# Access Compliance Report

## Public Rights-of-Way

### (Pedestrian Signals)

Intersection ID: N/A	Main Street:	Cross Street: N/A	Location: N/A
ADA ID: B174CA10B035	Signal Type: One Push Button-Non APS	Overall Compliance: No	Severity Score: BTN 1: N/A BTN 2: N/A No BTN: N/A
Codes/Mitigation Info/Possible Solution		Field Measurements/Component Compliance

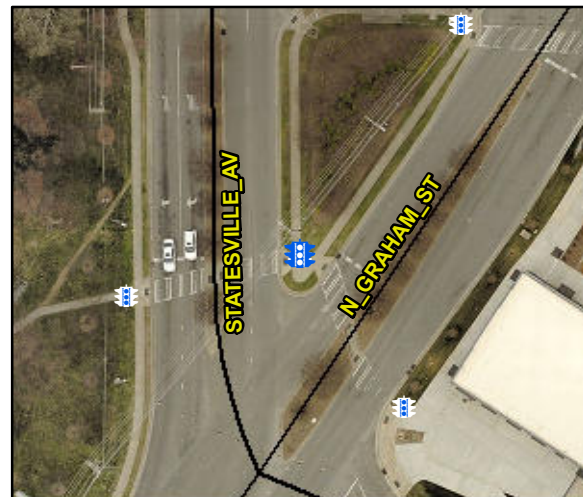
Surveyor Notes: TX HT 5/16

PROW/ADA: R410.6, TMUTCD 4e.08, R404.2, R404.3, R406.2

Yes	B 1 Clear Xing Direction?	ClearlyMarked	N/A	B 2 Clear Xing Direction?	N/A
	B 1 Crossing Direction	To SE		B 2 Crossing Direction	N/A
Yes	B 1 DistanceTo XWalk (in)	38.0	N/A	B 2 DistanceTo XWalk (in)	N/A
No	B 1 DistanceTo Curb (in)	170.0	N/A	B 2 DistanceTo Curb (in)	N/A
Yes	B 1 Diameter (in)	2.0	N/A	B 2 Diameter (in)	N/A

Possible Solutions: Replace Signal Push Button With APS Button on New Post. Remove & Replace Sign.
